- 6. Terra Firma Subdivision Johnson Addition
KPB File 2022-171**

KPB File # 2022-171
 S11 T04S R15W
 Anchor Point

ITEM 6 - TERRA FIRMA SUBDIVISION JOHNSON ADDITION

STAFF REPORT

PLAT OF
**TERRA FIRMA SUBDIVISION
 JOHNSON ADDITION**

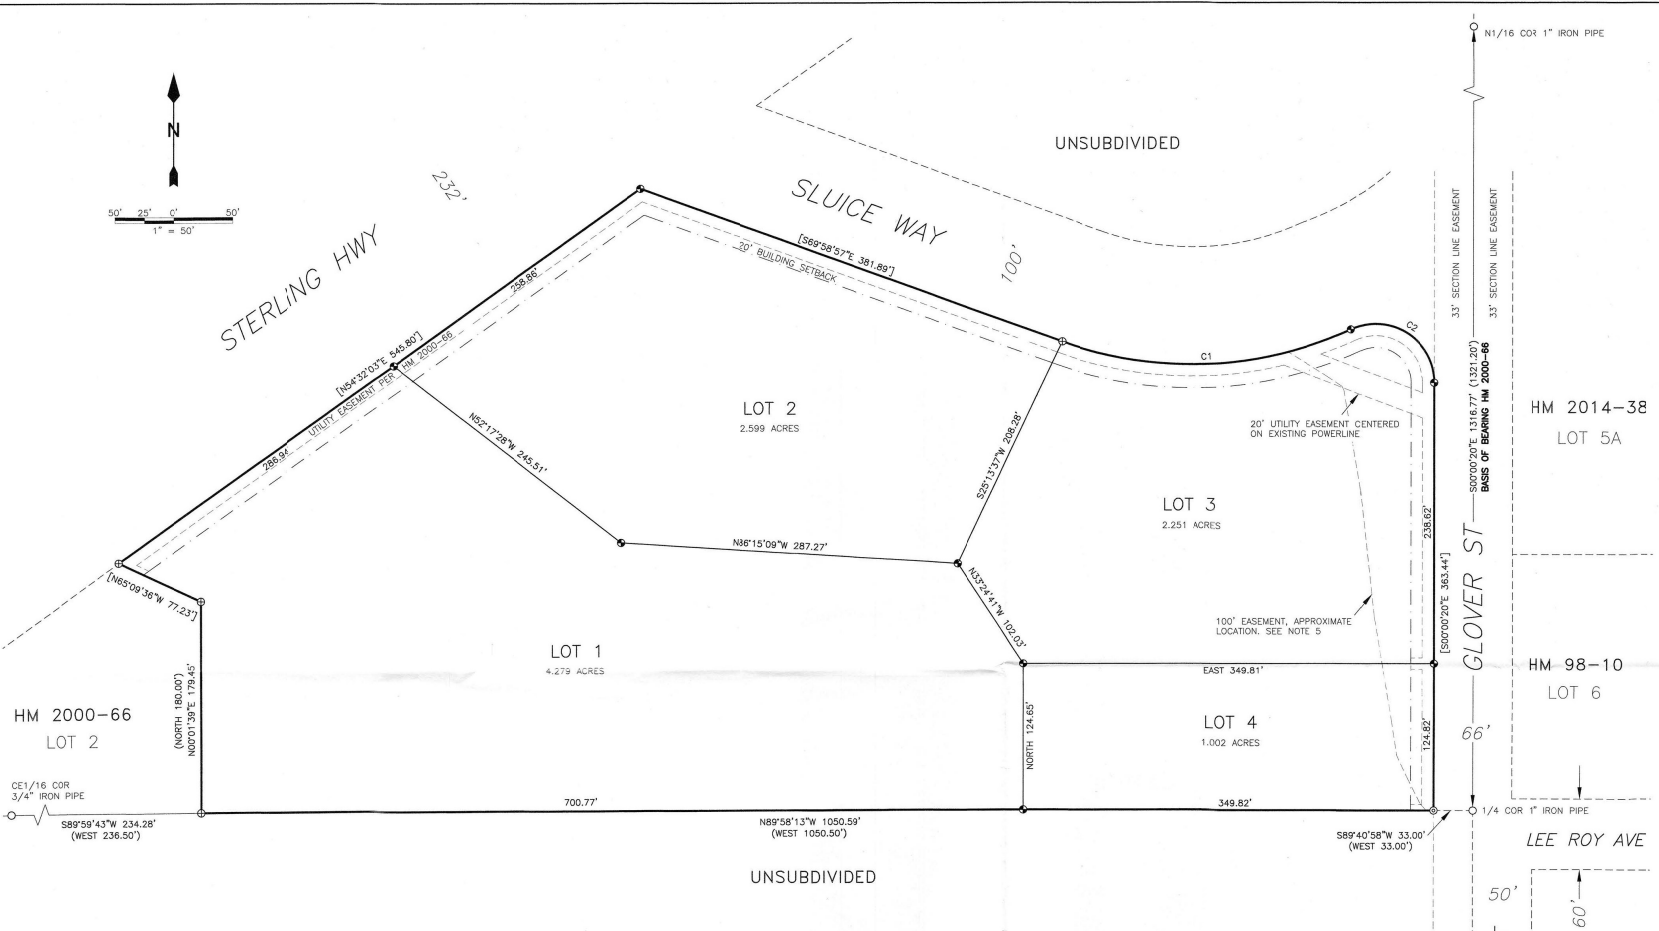
It appears that a portion of constructed travelway is within proposed Lot 3 that appears to be the portion of the access easement that was used prior to dedications. Imagery from 1996 shows this portion constructed as the dedication did not occur until 2000. Current imagery shows the new constructed road within the dedication and what appears to be barriers to limit access through Lot 3. Staff requests verification from the surveyor when the field work is completed to let us know if that portion is still in use.

Staff recommends source for highway information should be cited either by label or plat note.

There are improvements located on the subdivision that will be located on Lot 2 of the proposed subdivision. There does not appear to be any encroachment issues but the surveyor will need to confirm the back structure will not encroach the new property line.

Utility Easements Terra Firma Subdivision, Plat HM 2000-66, granted 10 foot utility easements adjoining dedicated rights-of-way that increased to 20 feet within 5 feet of side lot lines. The 10 foot easement is depicted and labeled per HM 2000-66. **Staff recommends** the label include the width.

Per plat note 1 this plat will also be adding to the existing easement by granting 20 feet within 5 feet of the new side lot lines. **Staff recommends** the depiction be updated to show the 20 foot along all side lot lines.

A 20-foot utility easement centered on the existing power line located on the east side of the subdivision coming from the parent plat. HEA has requested the source of the easement be stated. **Staff recommends** that the easement be labeled “as granted on plat HM 2000-66”.

HEA	Provide a label for the width of the easement of record (10 ft). Add "as granted on plat 2000-66 HM" on 20 foot easement
ENSTAR	No comments or recommendations
ACS	No objections
GCI	Approved as shown

- G. The status of adjacent lands within 100 feet of the proposed subdivision boundary or the land status across from any dedicated rights-of-way that adjoin the propose subdivision boundary, including names of subdivisions, lot lines, block numbers, lot numbers, rights-of-way; or an indication that the adjacent land is not subdivided;
Staff recommendation: Provide a depiction of the centerline of the Sterling Highway, if less than 100 feet to centerline then include the full width of the Sterling Highway in the depiction.
- N. Apparent encroachments, with a statement indicating how the encroachments will be resolved prior to final plat approval;
Staff recommendation: There is an existing structure that looks like it may be close to the new lot line. This will require verification and resolution if found to cross the new lot line.

Platting Staff Comments: Soils analysis report will be required and an engineer will need to sign the plat.

- “No access to state maintained rights-of-way permitted unless approved by the State of Alaska Department of Transportation.”
- Add the reservation of easement for highway purposes as described in the Certificate to Plat including all order numbers and dates.

Correct plat note 5 to “...et al...”
